**TSG-RAN Meeting #8
Düsseldorf, Germany, 21 - 23 June 2000**

TSGRP#8(00)0248

Title: Agreed CRs to TS 25.427

Figure 11: Uplink data frame structure

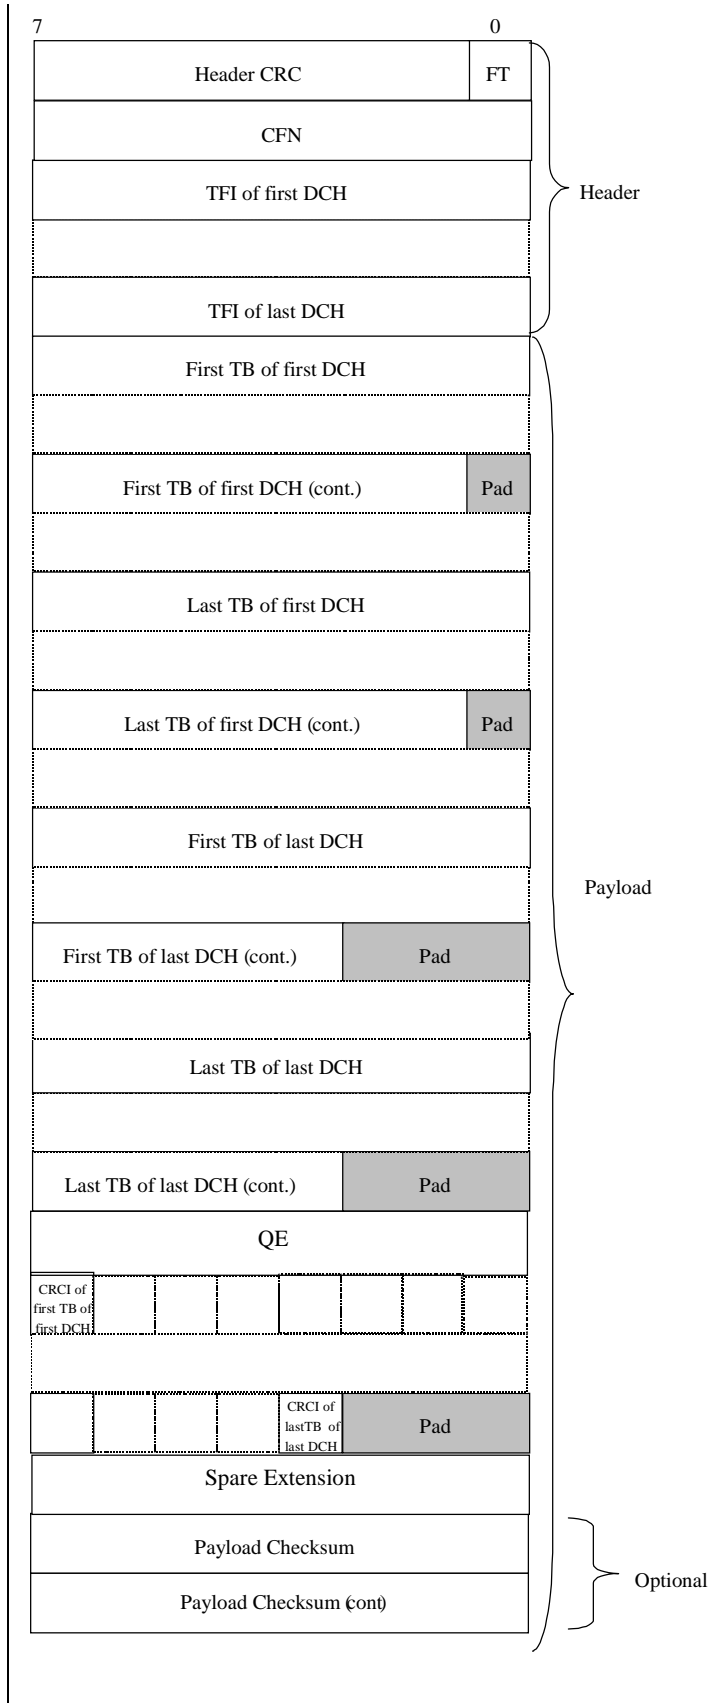
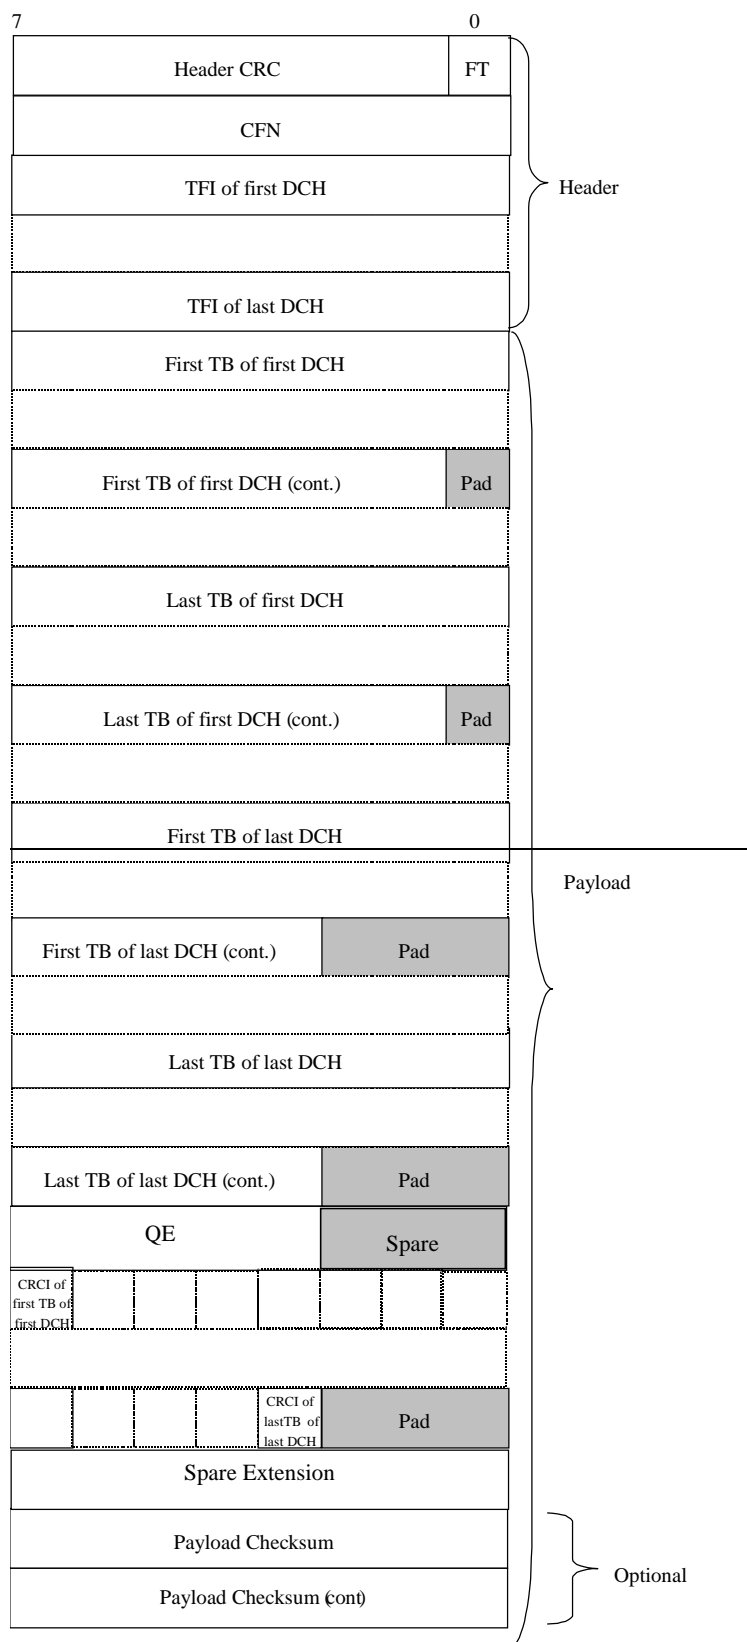
6.2.4.5 Quality Estimate (QE)

Value range: {0-~~63~~255}, granularity 1

Field length: ~~6~~8 bits

Figure 1: Uplink data transfer

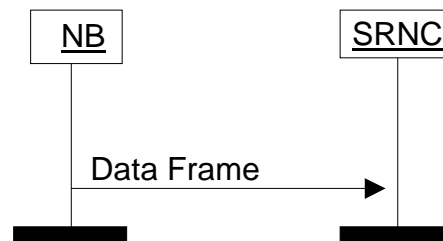
- In normal mode, the Node B shall always send an UL data frame to the RNC for all the DCHs in a set of coordinated DCHs regardless of the number length of Transport Blocks of the DCHs, ~~i.e. also when it has received zero bits for a transport channel during a certain TTI.~~
- In silent mode and in case only one transport channel is transported on a transport bearer, the node-B shall not send an UL data frame to the RNC when it has received a zero bits TFI indicating "number of TB equal to 0" for the transport channel during a ~~certain~~ TTI.
- In silent mode and in case of coordinated DCHs, when the Node B receives a zero bits bits TFI indicating "number of TB equal to 0" for all the DCHs in a set of coordinated DCHs, the Node B shall not send an UL data frame to the RNC for this set of coordinated DCHs.
